Project	IEEE 802.16 Broadband Wireless Access Working Group < http://ieee802.org/16 >	
Title	DL-MAP and UL-MAP CID Table IEs	
Date Submitted	2005-03-09	
	Mary Chion Sean Cai Jason Hou Jing Wang Dazi Feng Jun Han Irving Wang	mchion@ztesandiego.com scai@ztesandiego.com jhou@ztesandiego.com
	ZTE San Diego Inc. 10105 Pacific Heights Blvd. San Diego, CA 92121 USA	Voice: 858-554-0387 Fax: 858-554-0894
Re:	Response to Sponsor Ballot on IEEE802.16e/D6 document	
Abstract	The proposed DL-MAP and UL-MAP CID table IEs can be used to not only improve DL subframe efficiency but also significantly reduce unnecessary power consumption.	
Purpose	To incorporate the text changes proposed in this contribution into the 802.16e/D7 draft.	
Notice	This document has been prepared to assist IEEE 802.16. It is offered as a basis for discussion and is not binding on the contributing individual(s) or organization(s). The material in this document is subject to change in form and content after further study. The contributor(s) reserve(s) the right to add, amend or withdraw material contained herein.

DL-MAP and UL-MAP CID Table IEs

Figure 208c. Association for DL-MAP CID Records and DL/UL MAP Data Burst Allocation

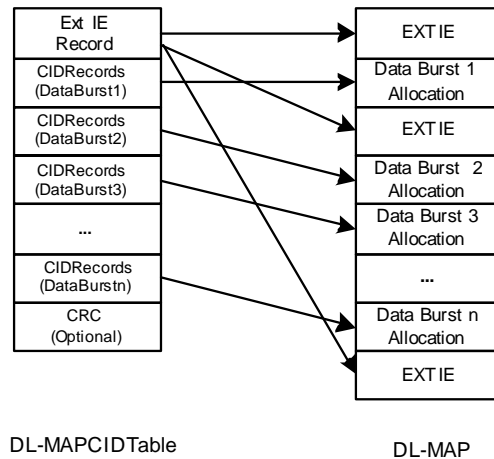
The association of DL-MAP CID table IE records and DL_MAP allocations are shown in Figure 208c.
